**ADDENDUM NO. 3**

March 4, 2016

**Re: Sanford High School and Technical Center  
12-067-00**

**S1.9**

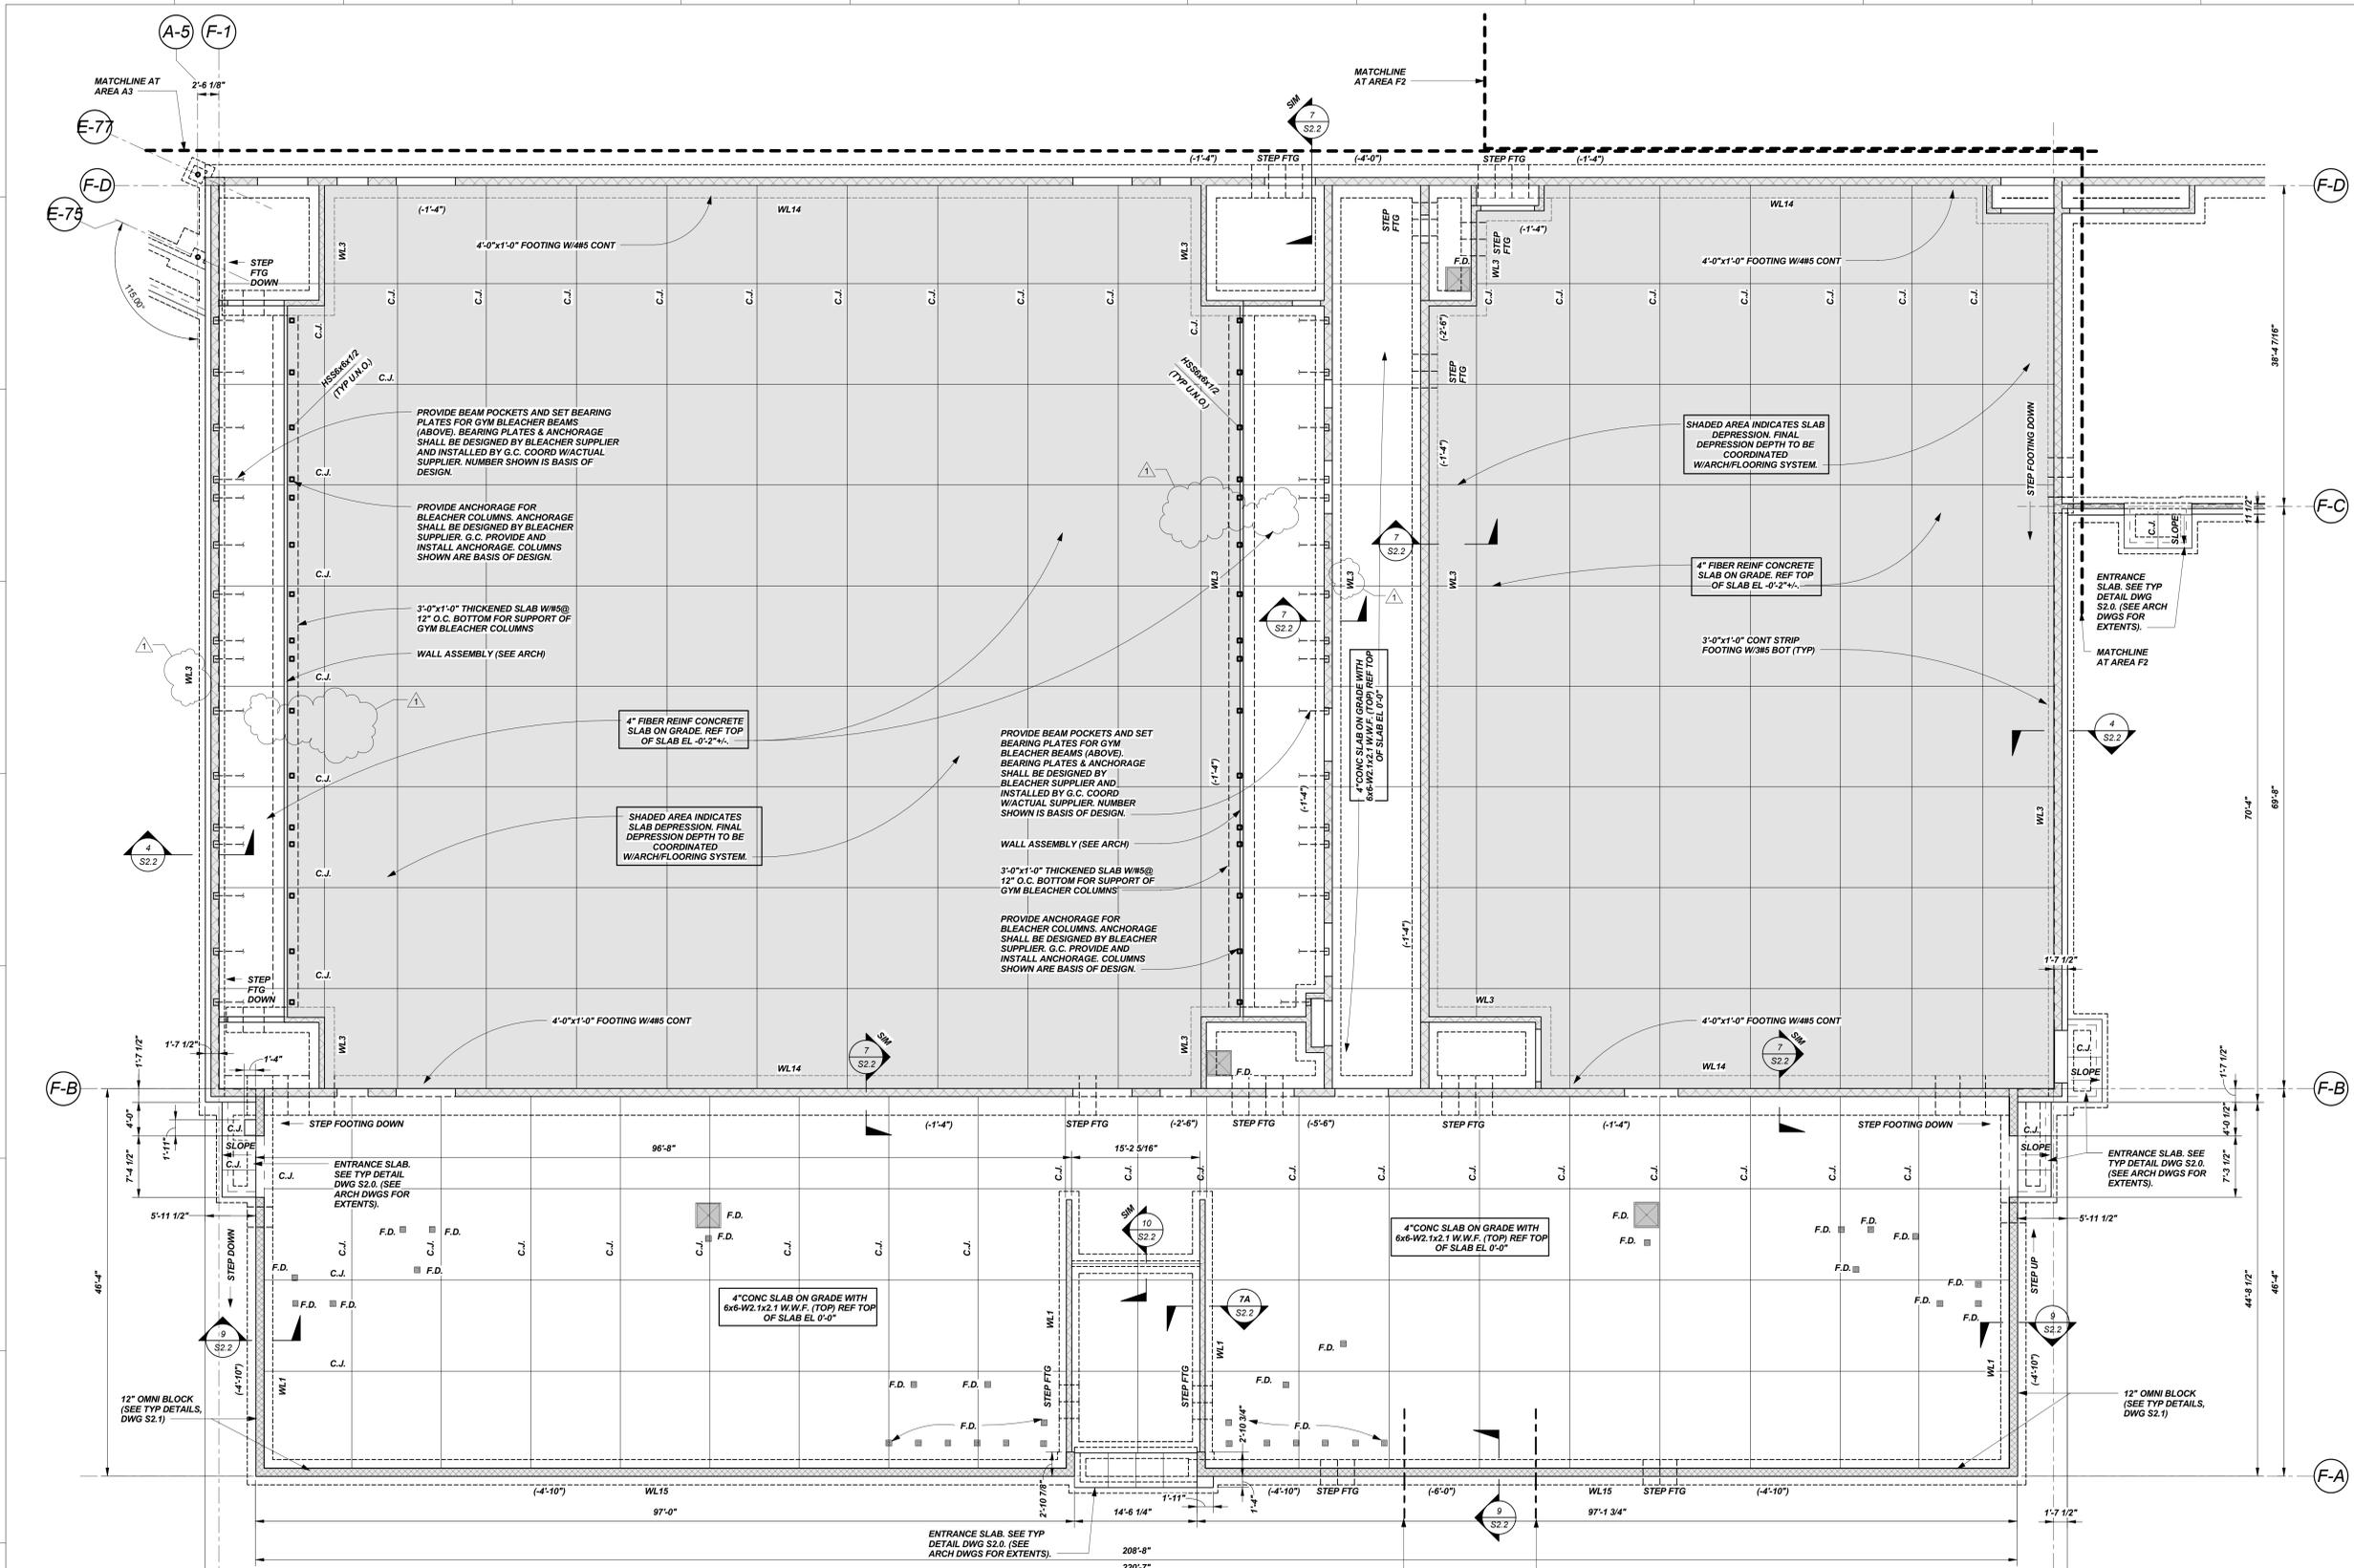
**Item No. 3.59** Reference Drawing S1.6, S1.3, S1.5, S1.9. Question: Line CE-1 from line C-1 to match line shows both sections 4/S2.2 & 4A/S2.2. Please verify.

Answer: Attached drawings S1.3, S1.5, S1.6 & S1.9 clarify this section and other foundation sections in certain locations. Rammed Aggregate Pier loads are clarified on S1.9. Note 4A/S2.2 specifies a 4 foot wide footing. Note 7 "Sim"/S2.2 specifies a 4 foot wide footing.

**SLIPFORM CURB SECTION AT PERMEABLE PAVERS**  
NOT TO SCALE

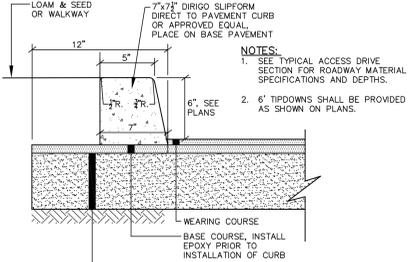
**Item No. 3.51 Reference Drawing C9.** Question: What does the concrete curb sit on in the permeable paver parking area? Answer: See attached updated drawing C66 with added detail for this condition.
